Application is hereby made for revising the plan(s) for: Preliminary/Final Land Development Plans for JPMorgan Chase Bank

RE: Preliminary/Final Land Development Plan Review
JPMorgan Chase Bank, N.A.
1729 Street Road
TMP # 02-043-305
Bensalem Township, Bucks County, PA
Project No. BENS R 1280

We are in receipt of the JPMorgan Chase Bank, N.A. Preliminary/Final Land Development Plan Review Letter dated July 14, 2021. Please find enclosed responses to the previously mentioned documents.

SHEET NO.
C19.1
 SHEET 20 OF 23

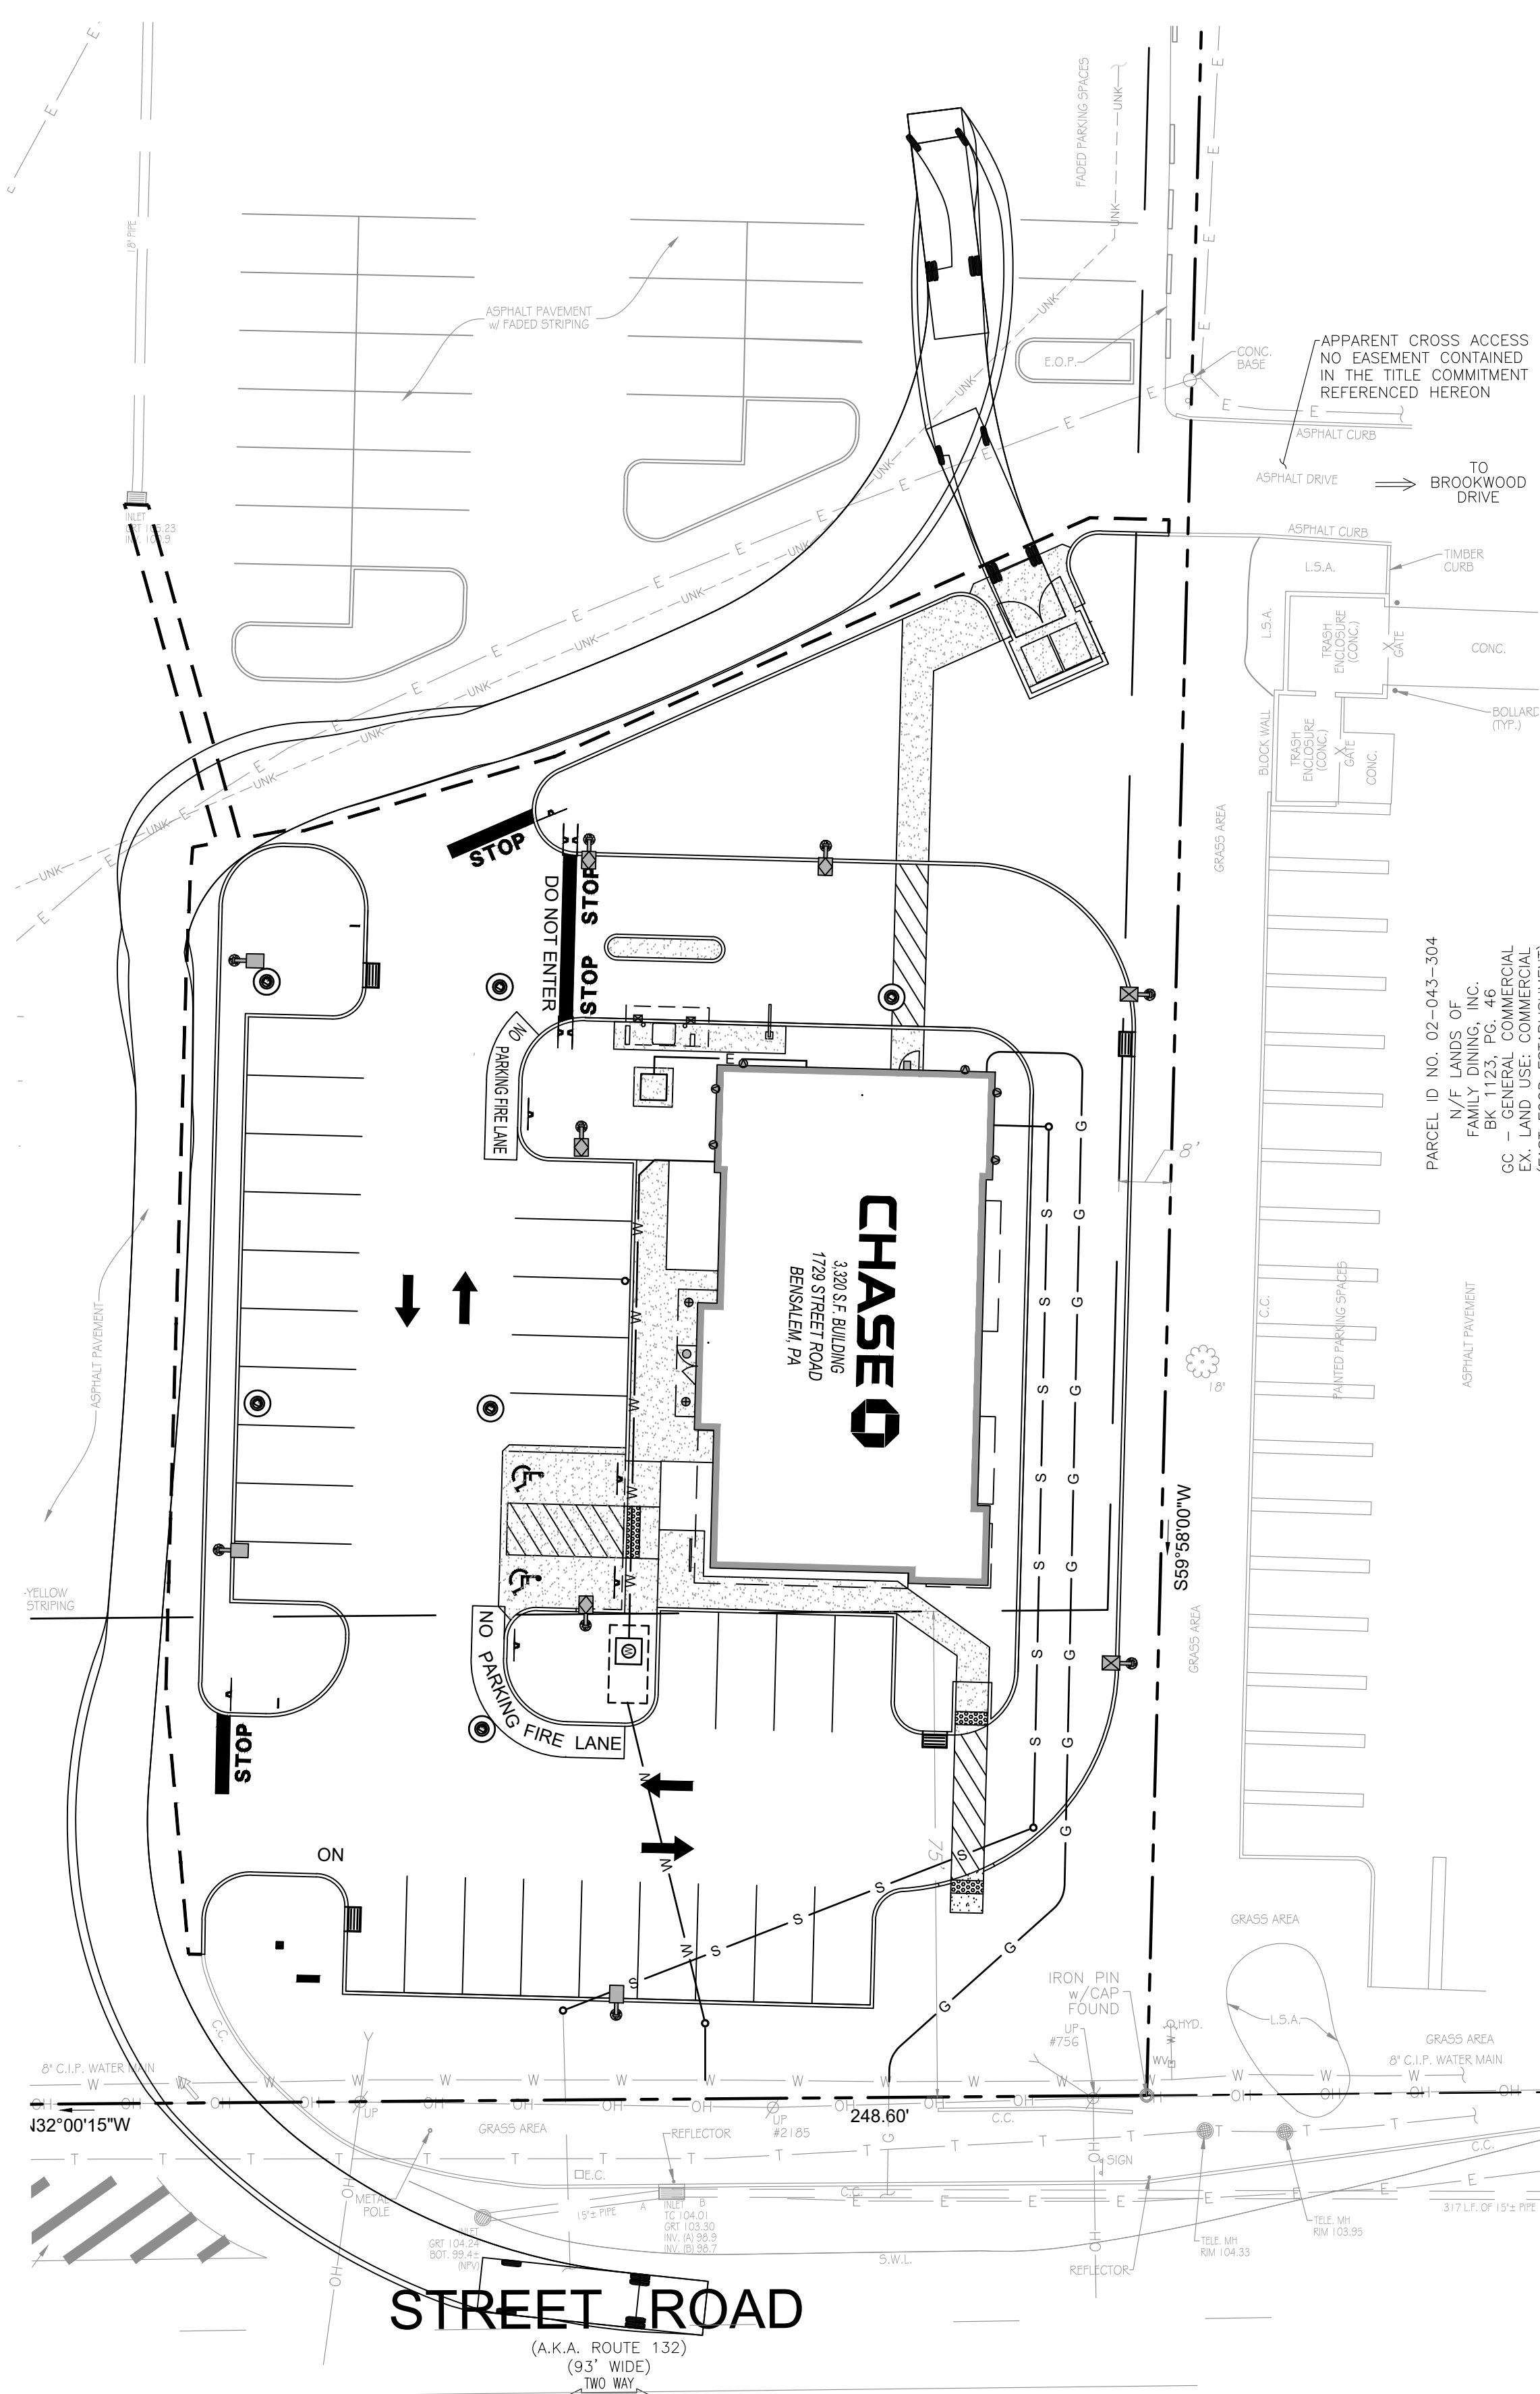
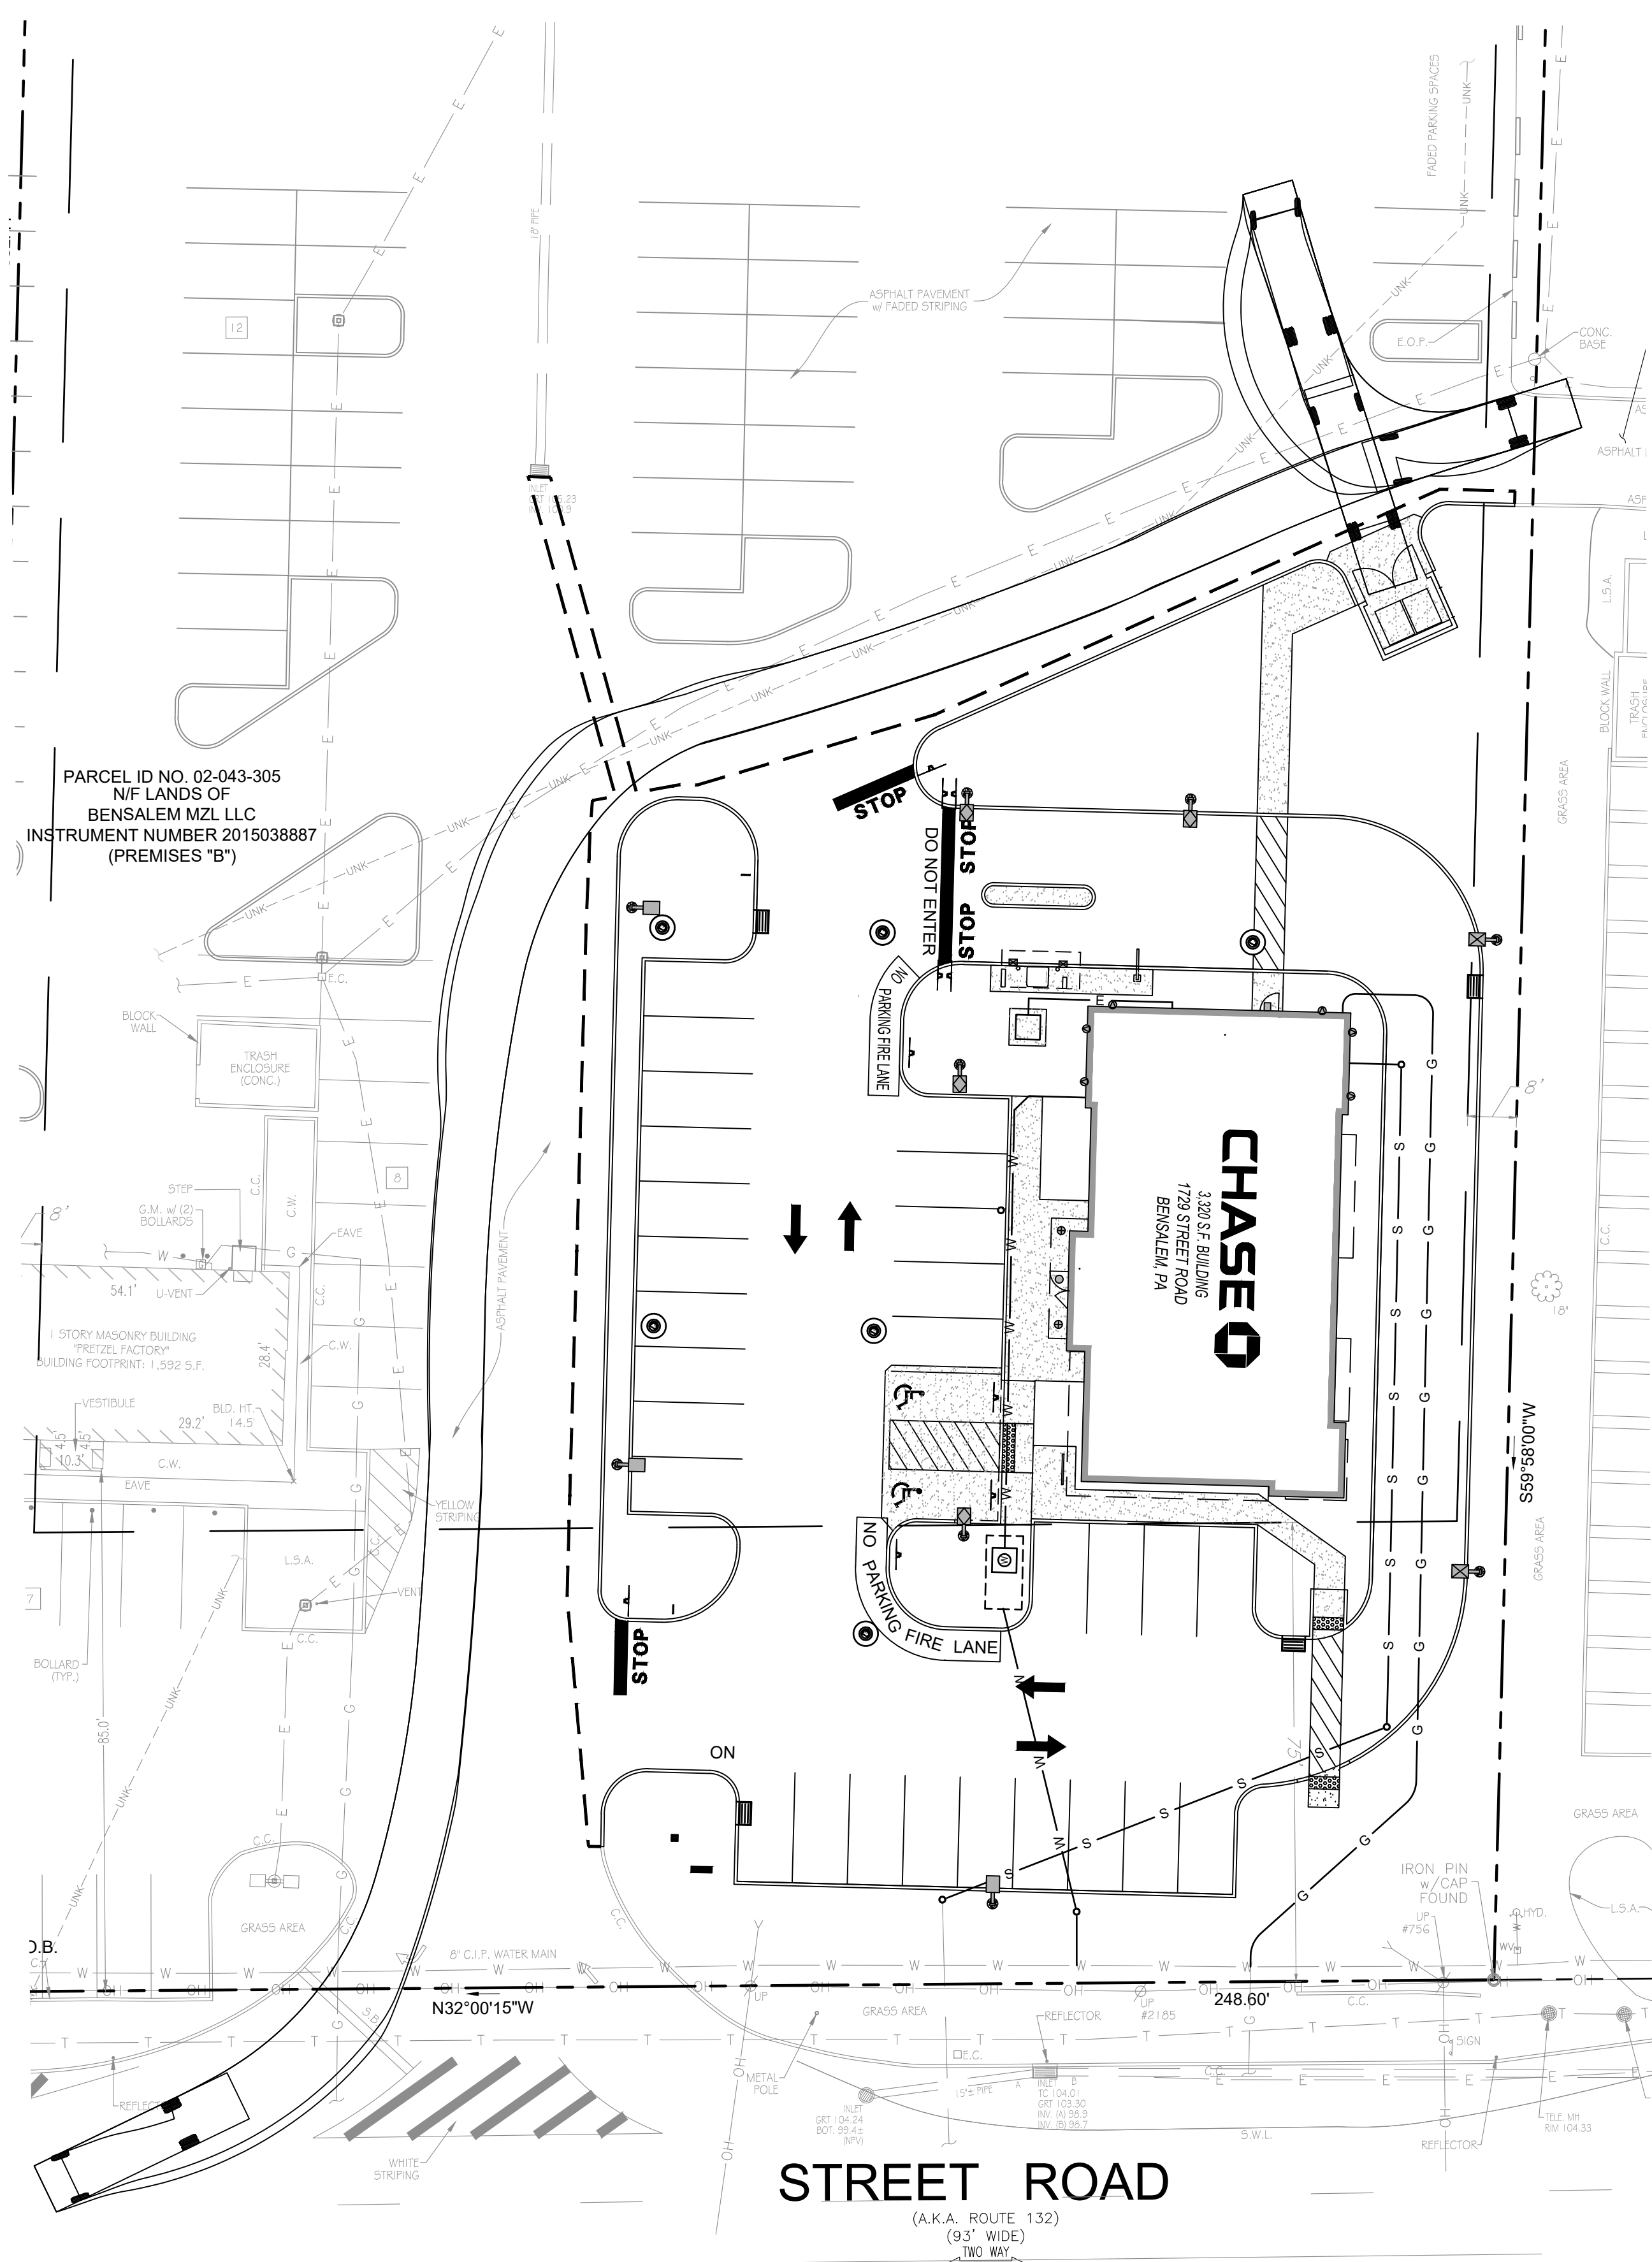
The Emergency Access Plan shows that a firetruck would top the curb and hit light poles in several locations. This must be revised.

- Response 8** **Completed. Please see the Site Plan – Sheet C5.1 (Sheet 5 of 23).**
- Comment 9** Revise the truck turns to avoid tracking over site features. This includes curbing and site lighting poles.

Response 2 **Completed. Per the Township Fire Rescue Department Review letter dated May 21, 2021 and conversations with Robert Sponheimer, the fire lanes have been added to the plans. The Emergency Access Plan has also been updated per the review letter and conversations. Please see the revised Site Plan – Sheet C5.1 (Sheet 5 of 23) and Emergency Access Plan – A – Sheet C19.1 (Sheet 20 of 23).**

- Response 9** **Completed. Please see the Emergency Access Plan – A & B – Sheets C19.1 & C19.2 (Sheet 20-21 of 23).**
